Name The Career Academy - Bid Package 3  
Owner SCC  
Bids Due 6/5/2014 Time 2:00 p.m.

Number 2

ADDENDUM #2 – PART 1  
Bid Package 3

PROJECT:	LPS-SCC Career Academy	PROJECT NO.	L13414
FROM:	BVH Architects	DATE:	05/29/2014
TO:	Hampton Commercial Construction, Inc.	ADDENDUM	#2

**PARTIAL AREA A FOUNDATION PLAN**

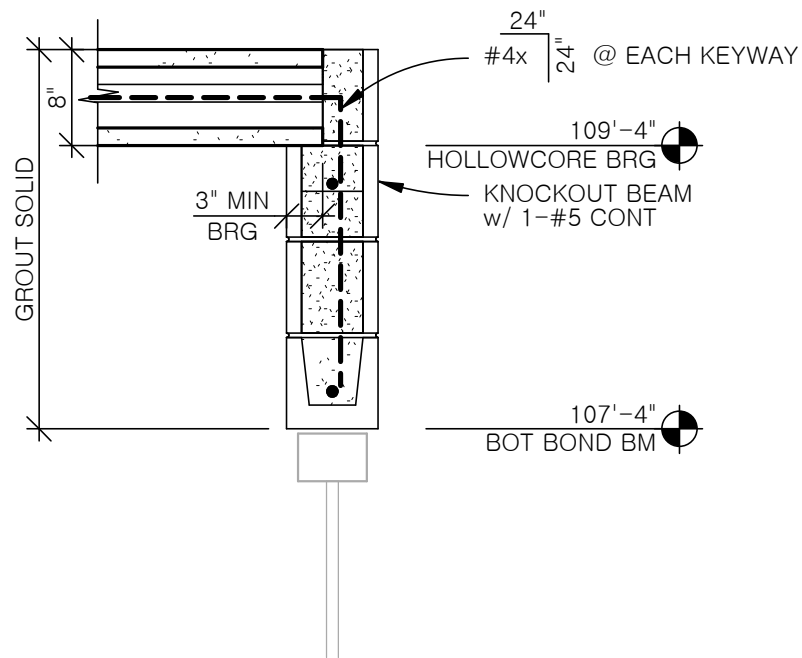
17. Sheet S1.0A – AREA A FOUNDATION PLAN
- a. See attached sheets S10 for revised partial plan.
18. Sheet S1.1C – AREA C LOW ROOF AND AREA B MEZZANINE FRAMING PLAN

1  FRAMING DETAIL F18/S1.1C

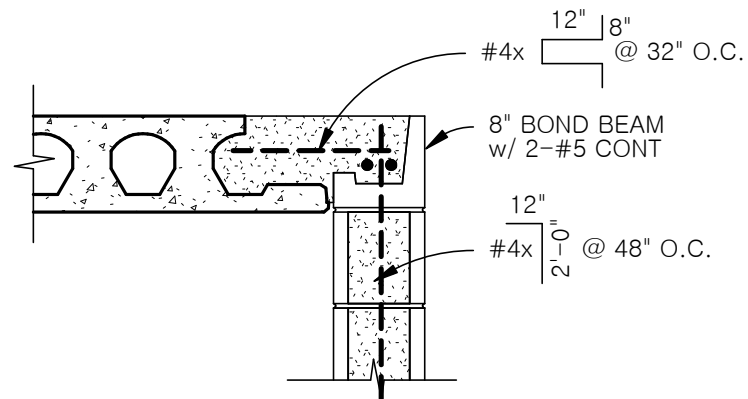
- b. See attached sheet S11 for revised partial plan.
  - c. See attached sheet S12 for new details
19. Sheet S2.0 – TYPICAL DETAILS
- d. See attached sheet S3 for revised detail.
